ADDENDUM 1

DATE: November 3, 2017

Contract 17-C-00031; Howard F. Curren AWTP Screen and Grit Building 2 Grit Washer Replacement

HOWARD F. CURREN AWTP SCREEN AND GRIT
BUILDING 2 GRIT WASHER REPLACEMENTS
GRIT UNIT ELECTRICAL LOWER PLAN

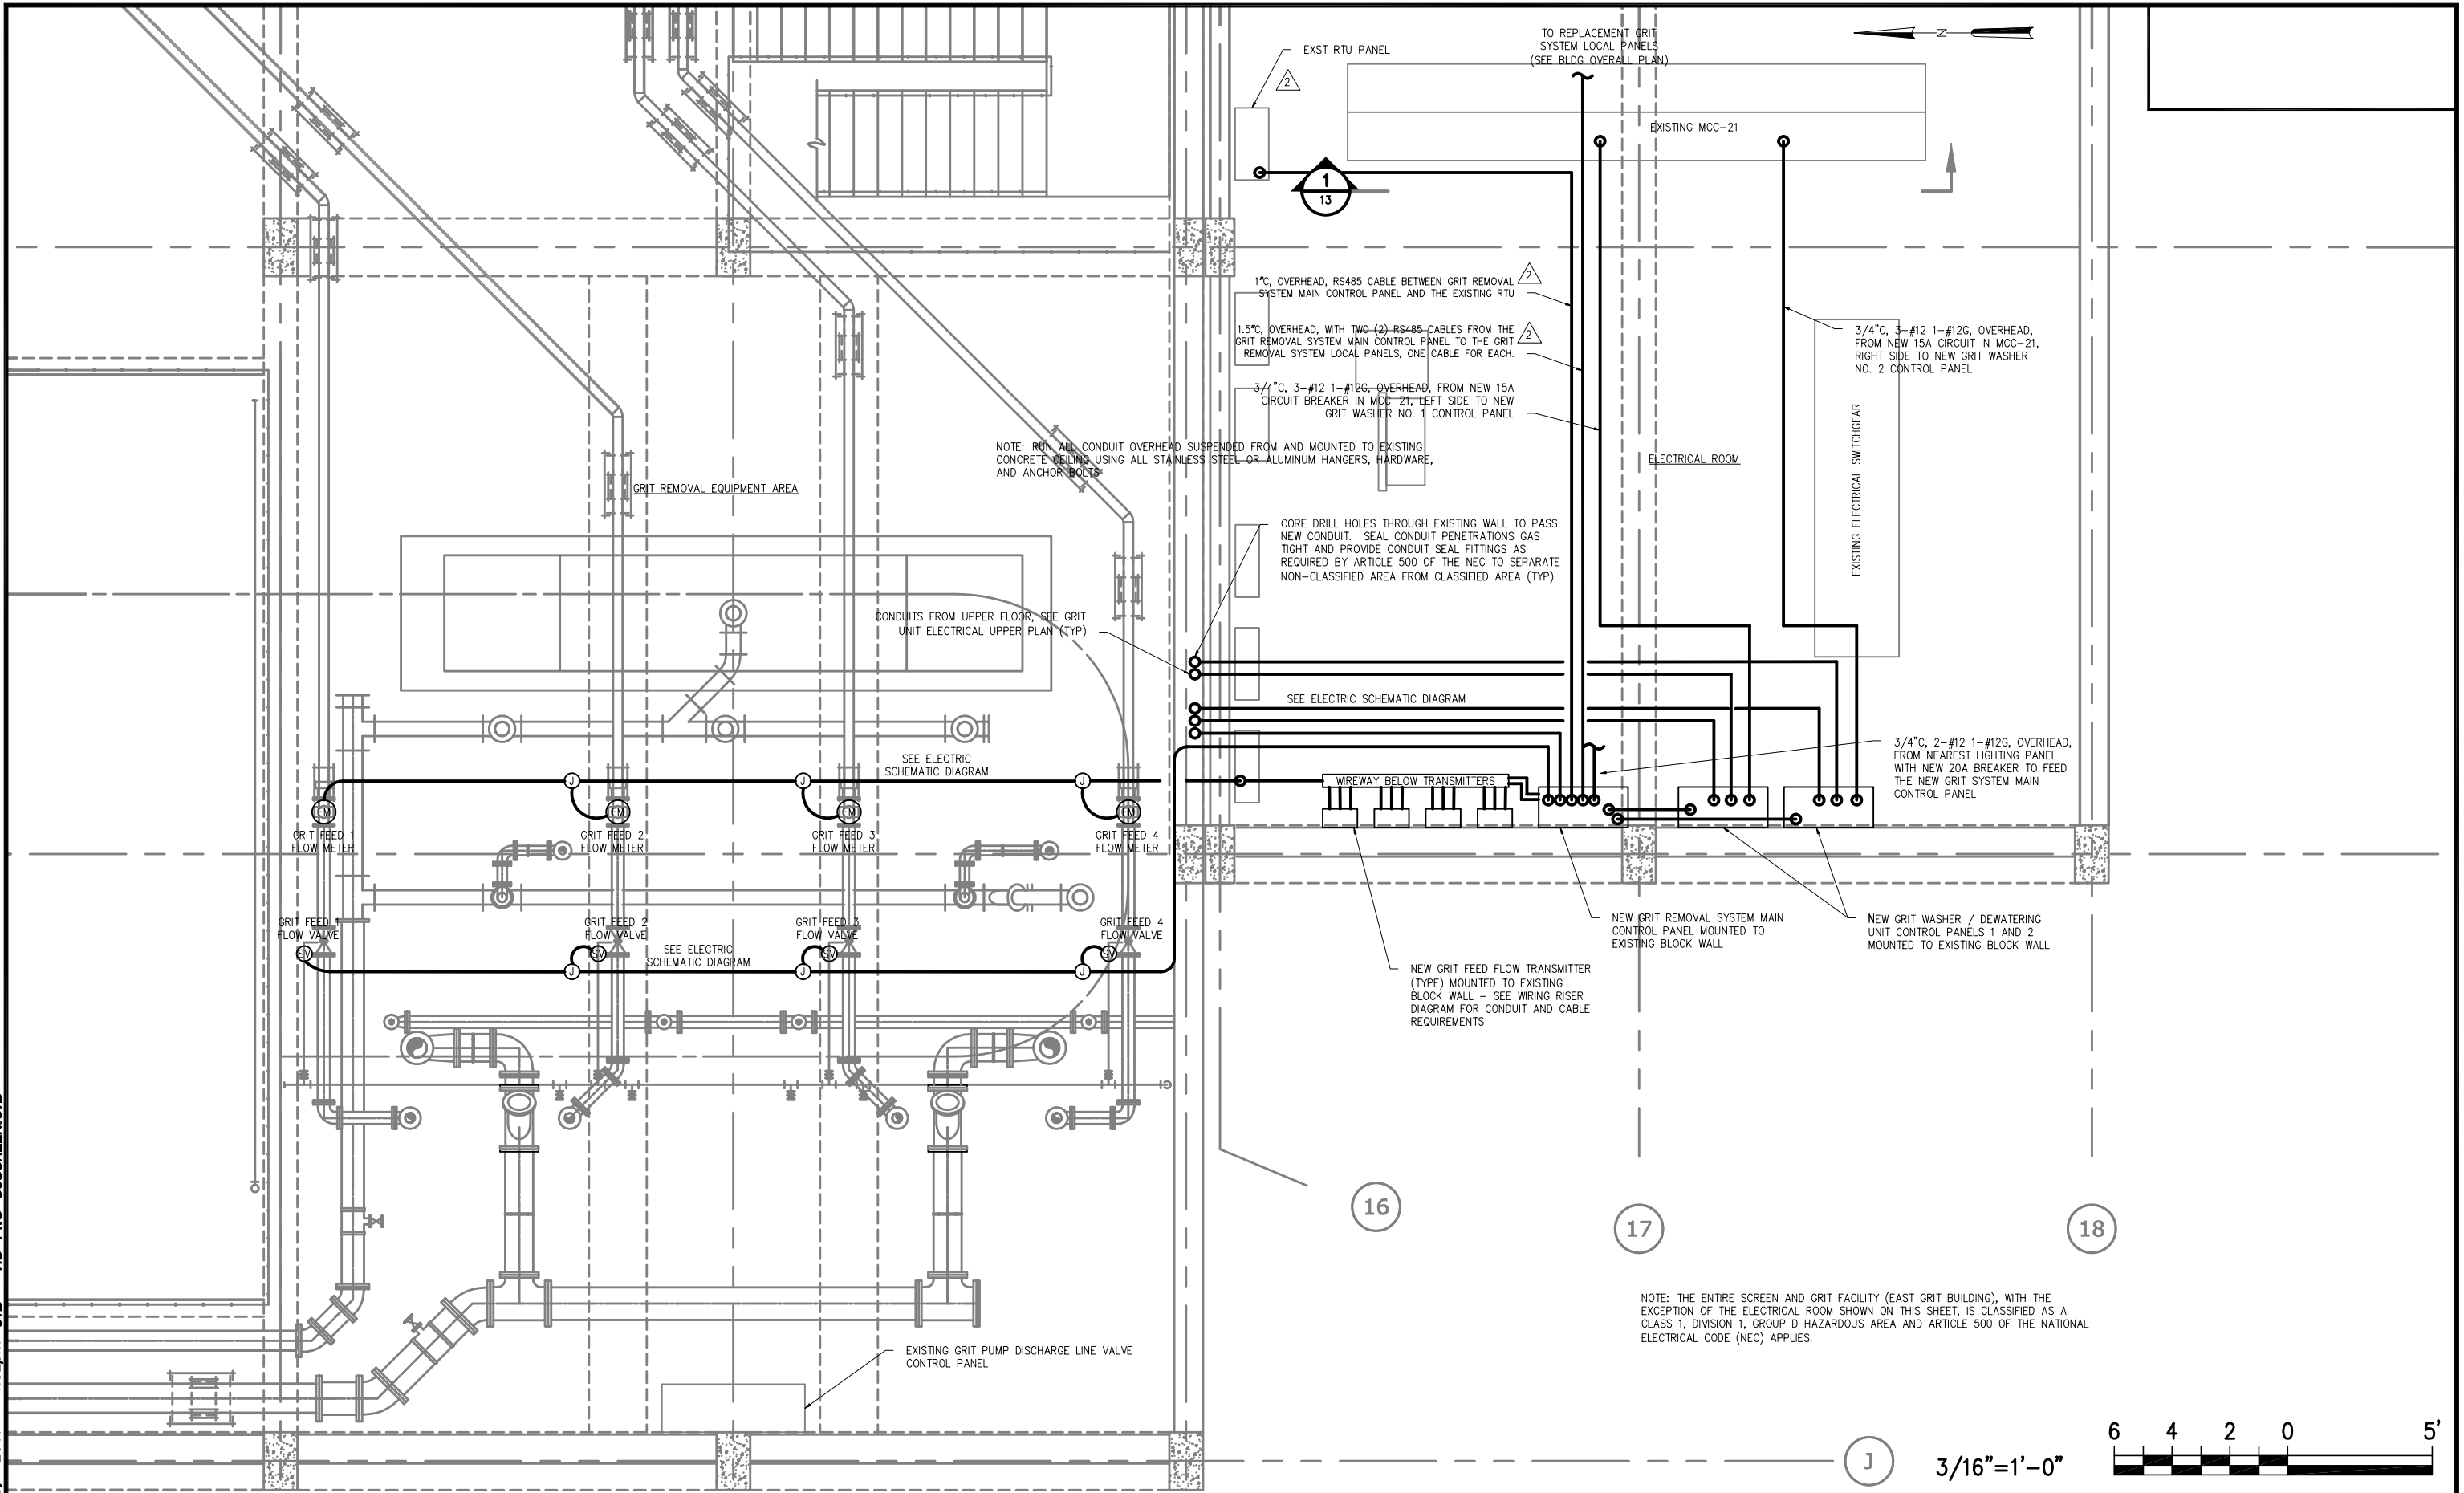
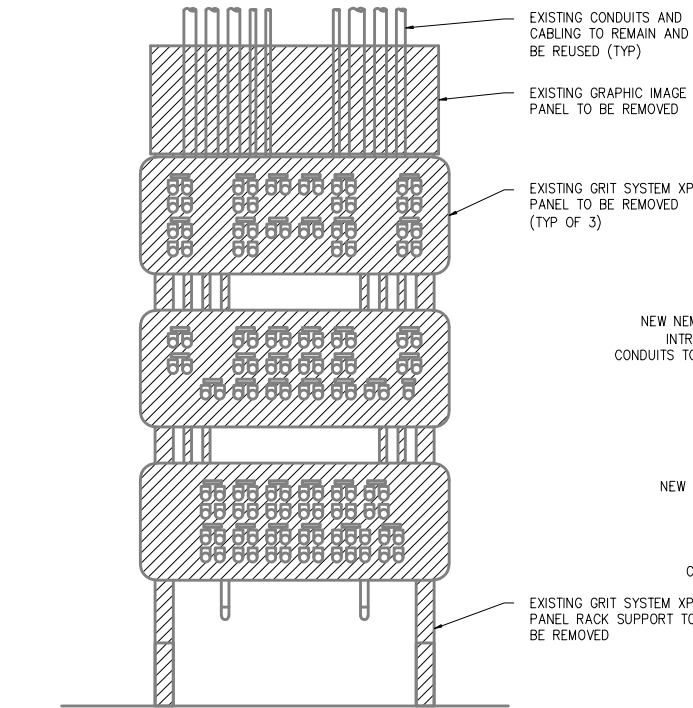
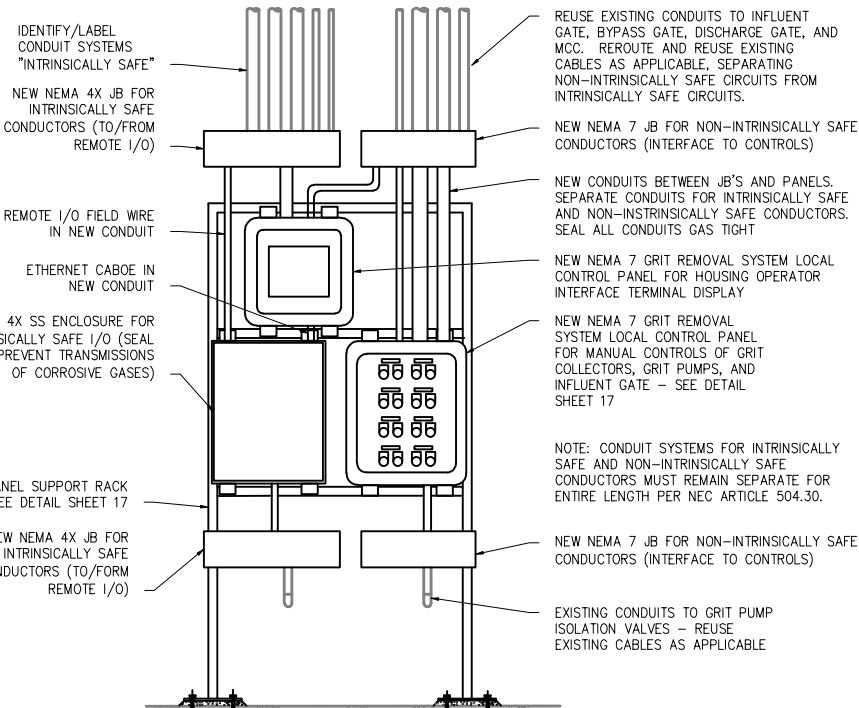
Item 6: Replace Plan Sheet 14 Grit Unit Electrical Lower Plan with the attached Plan Sheet 14.

GRIT REMOVAL SYSTEM CONTROL PANEL, CONDUIT, AND
WIRING SCHEMATIC DIAGRAM

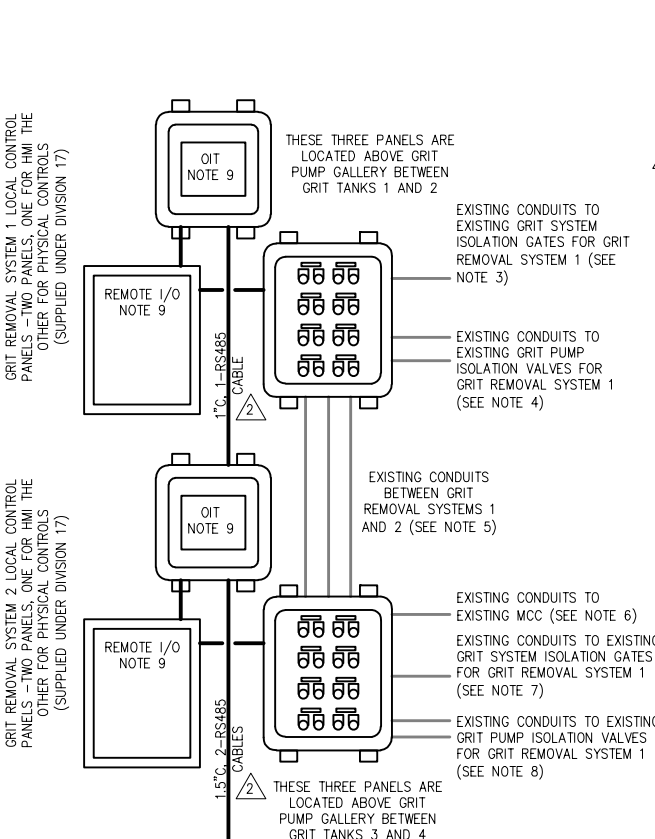
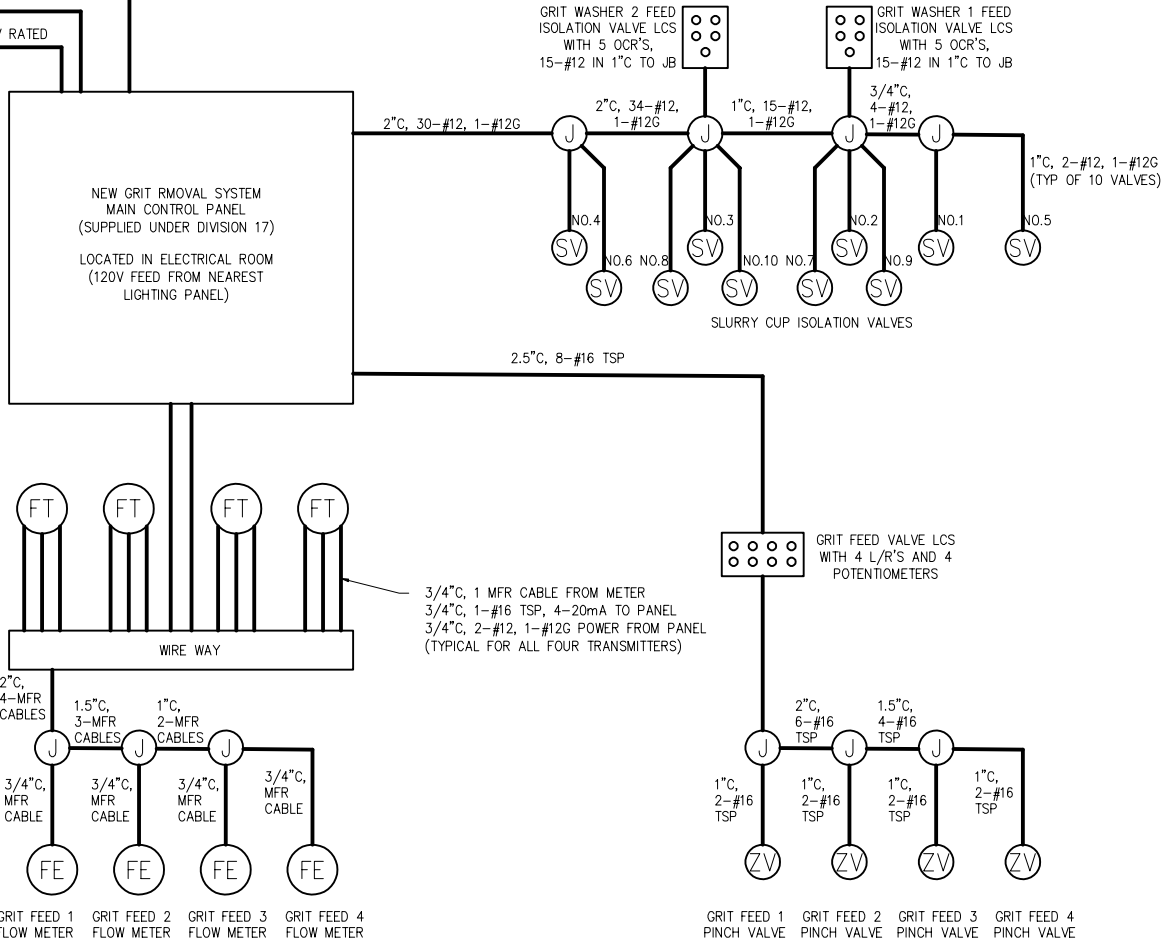
Item 7: Replace Plan Sheet 16 Electrical Schematic Diagram with the attached Plan Sheet 16.
